SERVICE BULLETIN

AA-SB-53-001

Harness Attach Bracket – Installation of fuel tank chafing protection

Figure 2.1: U Channel Bracket (Dimension in inch and mm in brackets)

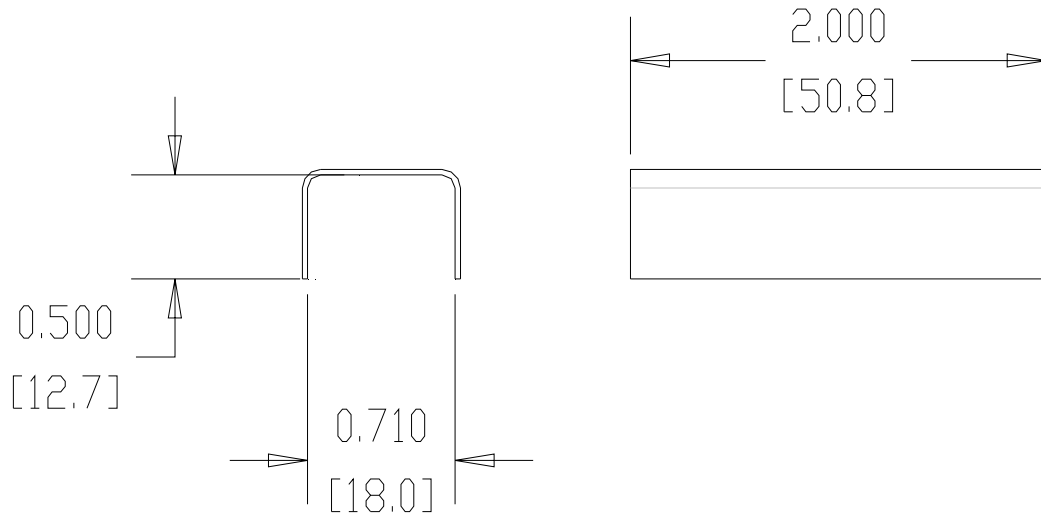
To protect the fuel tank from scuffing and fretting against the harness attach bracket, a U-channel bracket may be fabricated, and installed between the harness attach bracket and the fuel tank. This bracket provides a larger contact surface and will prevent the harness bracket from cutting into the rubber pad protecting the fuel tank. The U-channel bracket may be fabricated from 300 series stainless steel or Alclad 2024 sheet 0.032" to 0.040" thick. Dimensions for the U-channel is given in figure 2.1 below: Install the U-channel over the harness attach bracket (P/N 60-53-025-001). Apply AMS-S-8802 PRC type adhesive sealant or Araldite Epoxy to the inside sides of the U-Channel ensuring it bonds securely to the harness attach bracket. (Install a temporary packer below the U-Channel to push it up against the harness attach bracket if necessary, until the adhesive is cured.) Figure 2.2 shows the installation of the U-channel bracket.
